Project	IEEE 802.16 Broadband Wireless Access Working Group < http://ieee802.org/16 >
Title	Amendment to Idle Mode Service Primitives
Date Submitted	2007-03-1509
Source(s)	Jeehyeon Na, Jaesun Cha, JungMo Moon and Sangho Lee jhna@etri.re.kr ETRI 161 Gajeong-dong, Yuseong-gu Daejeon 305-700 Korea
Re:	Contribution on comments to IEEE 802.16g/D8
Abstract	Re-definition of Idle mode service primitives in section 14.2.4.2
Purpose	Adoption
Notice	This document has been prepared to assist IEEE 802.16. It is offered as a basis for discussion and is not binding on the contributing individual(s) or organization(s). The material in this document is subject to change in form and content after further study. The contributor(s) reserve(s) the right to add, amend or withdraw material contained herein.
Release	The contributor grants a free, irrevocable license to the IEEE to incorporate text contained in this contribution, and any modifications thereof, in the creation of an IEEE Standards publication; to copyright in the IEEE's name any IEEE Standards publication even though it may include portions of this contribution; and at the IEEE's sole discretion to permit others to reproduce in whole or in

Figure 479—Subscriber mode transition diagram at NCMS (on BS or MS side)

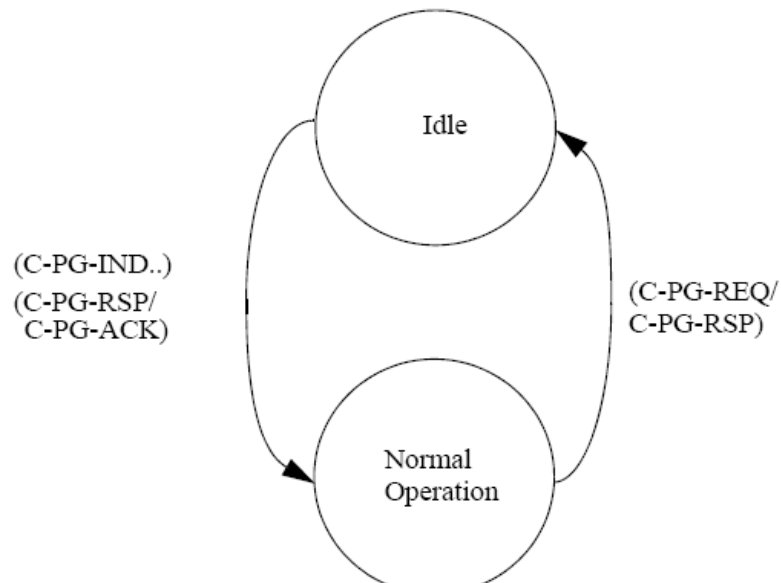
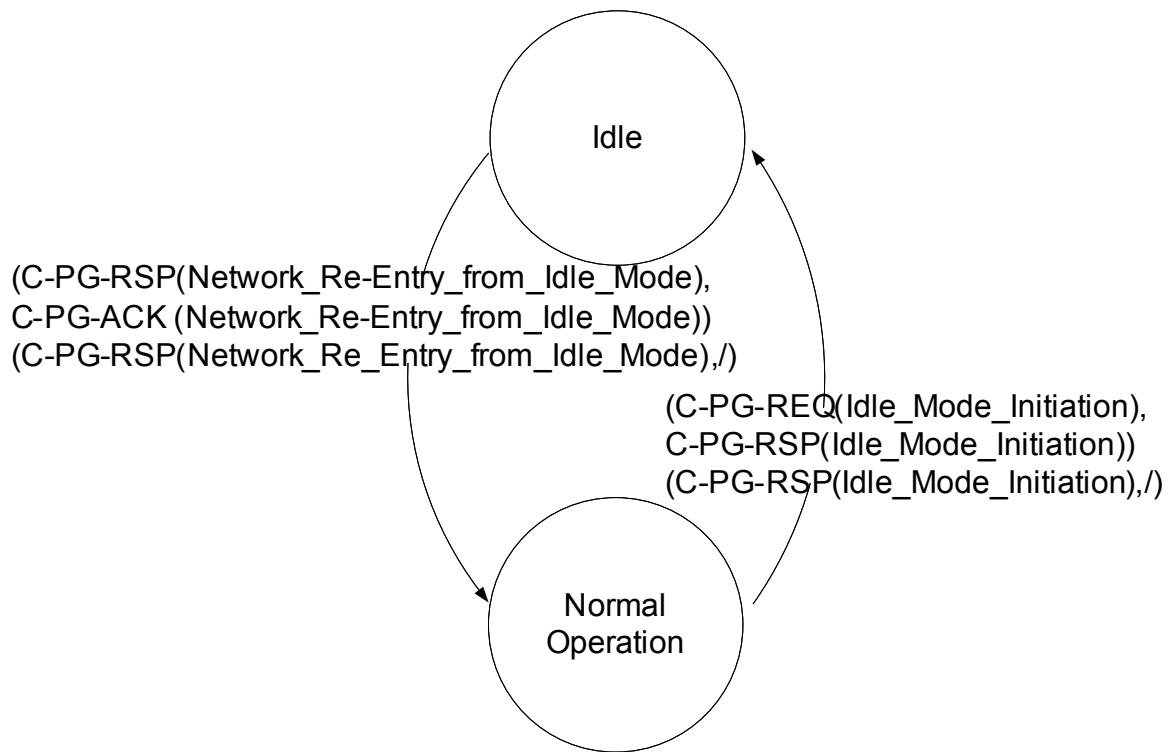
Subscriber mode management is described as informative in section 14.2.4 and it is managed at an MS, a BS and an NCMS. Figure 479 which shows subscriber mode transition diagram at an NCMS is not clear whether for an NCMS on a BS and an MS side or not.

Therefore, we clarify figure 479 and the related texts in order to be used both NCMS at an MS and a BS side.

Figure 479 shows Subscriber Mode transition diagram at the NCMS with service primitives related with the Subscriber Mode transition. Subscriber Mode transition from Normal Operation to Idle Mode is performed by exchanging C-PG-REQ and C-PG-RSP between a BS—an 802.16 entity and the NCMS after successful DREG-REQ message from the MS with De-Registration Request Code=0x01 or DREG-CMD message from the BS with Action Code = 0x05, where C-PG-REQ and C-PG-RSP are defined in 14.2.4.2.1 and 14.2.4.2.2, respectively. Subscriber Mode transition from Idle Mode to Normal Operation is initiated after exchanging C-PG-IND, C-PG-RSP, and C-PG-ACK between an 802.16 entity—a BS and the NCMS, where C-PG-IND, C-PG-RSP, and C-PG-ACK are defined in 14.2.4.2.4, 14.2.4.2.2, and 14.2.4.2.3, respectively.

Figure 480 – Idle mode initiation (NCMS on the MS side)

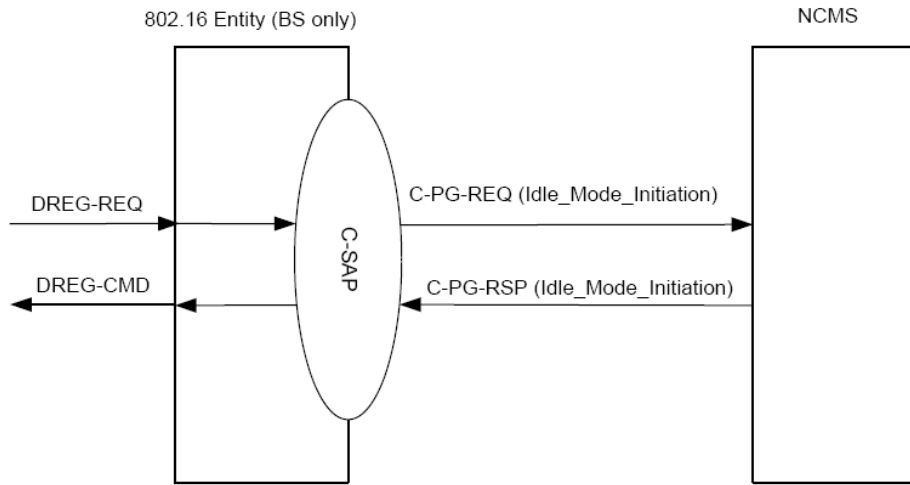
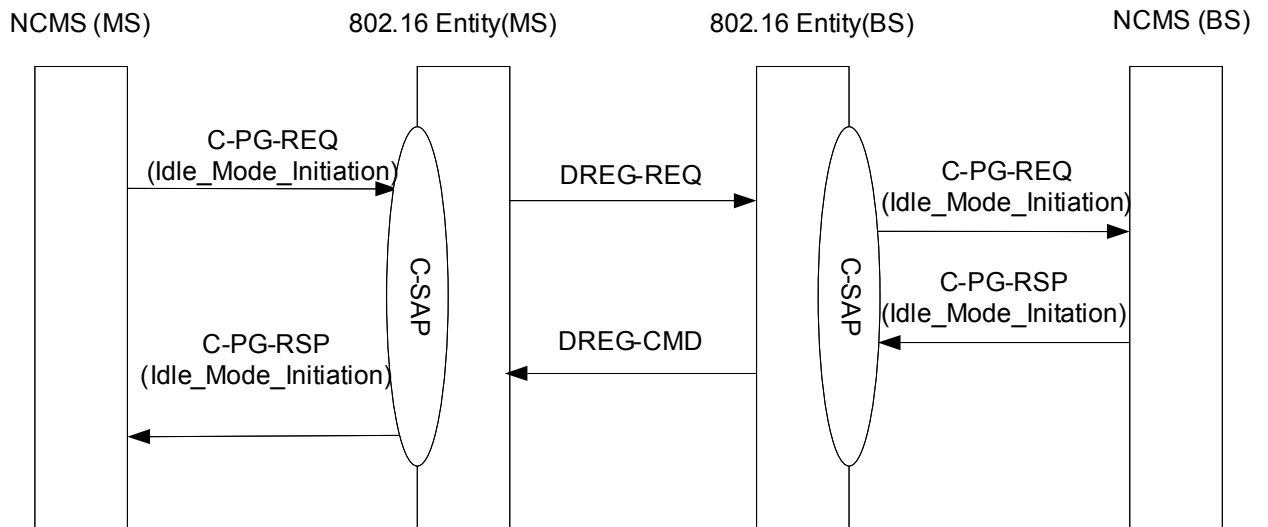
Therefore, we propose to change figure 480, 482, 483 to the figures which are included the service primitives between an 802.16 entity (MS) and an NCMS on the MS side and modify the related service primitives parameters in this contribution. And we also correct some editorial texts.

[Change the figure 480 and its title to as follows]

Figure 482- Paging Announcement

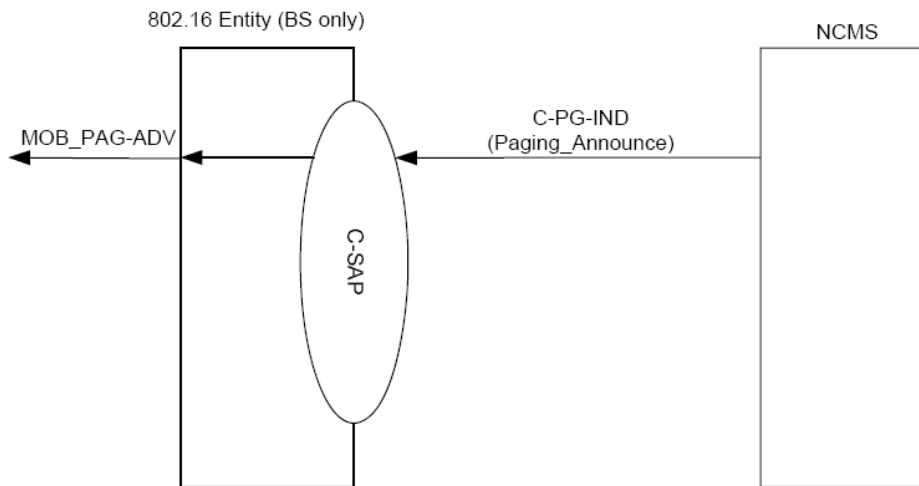
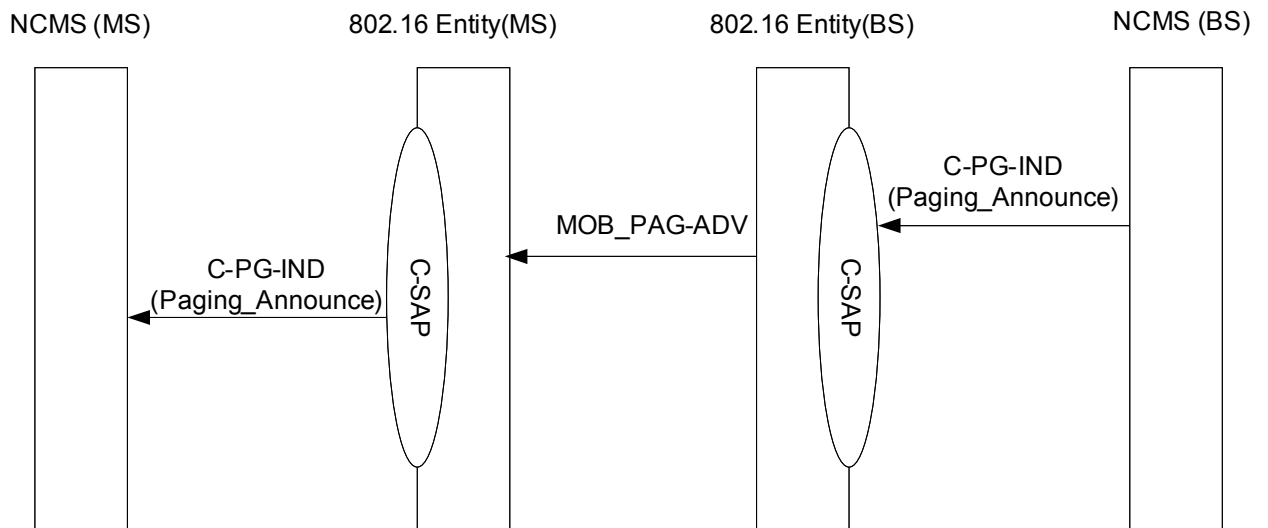
[Change the figure 482 to the following figure Section 14.2.4.2]

Figure 483- Network re-entry from Idle mode primitives

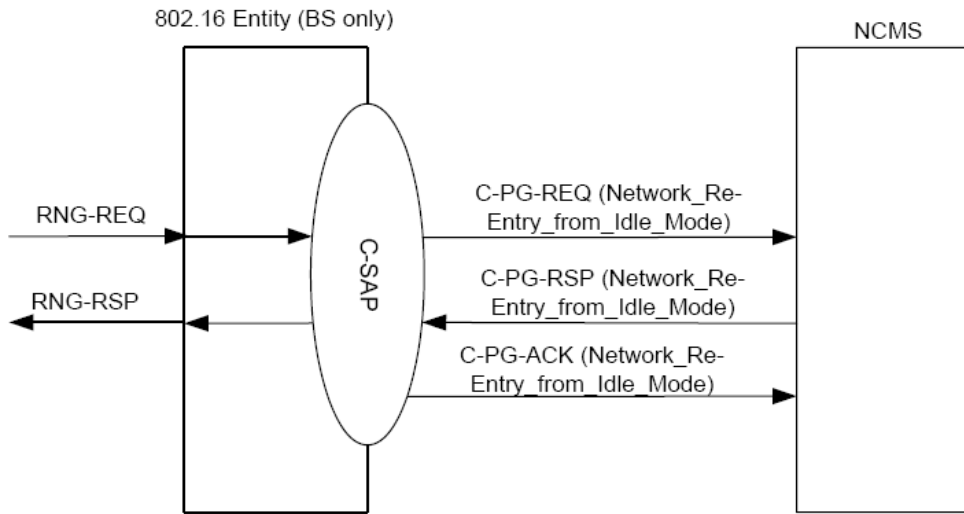
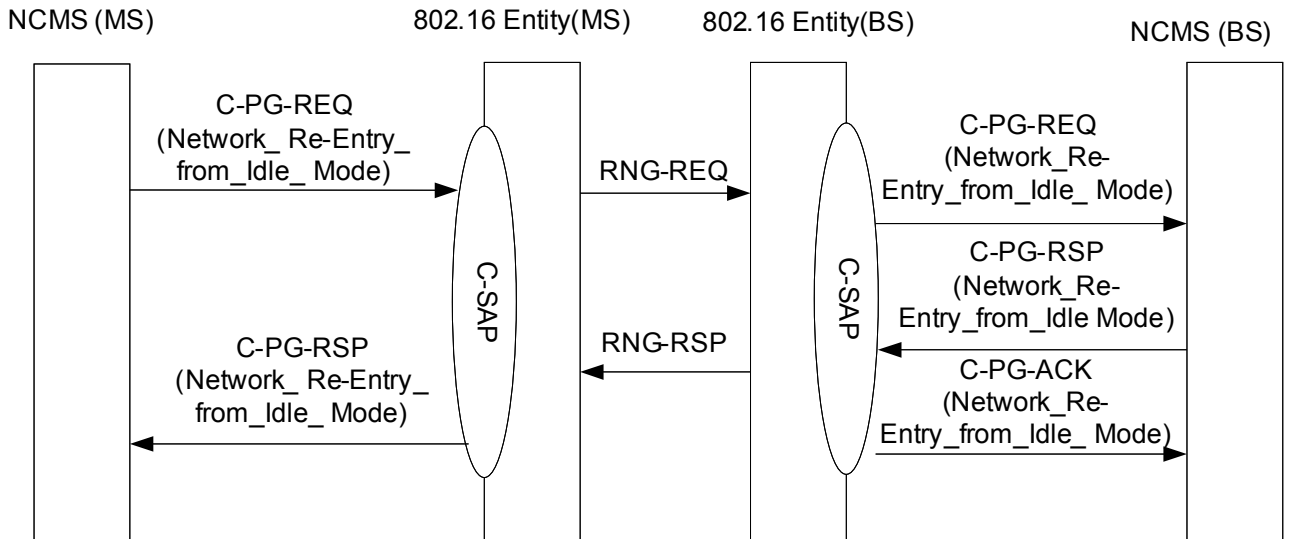
[Change the figure 483 to the following figure in 14.2.4.2]
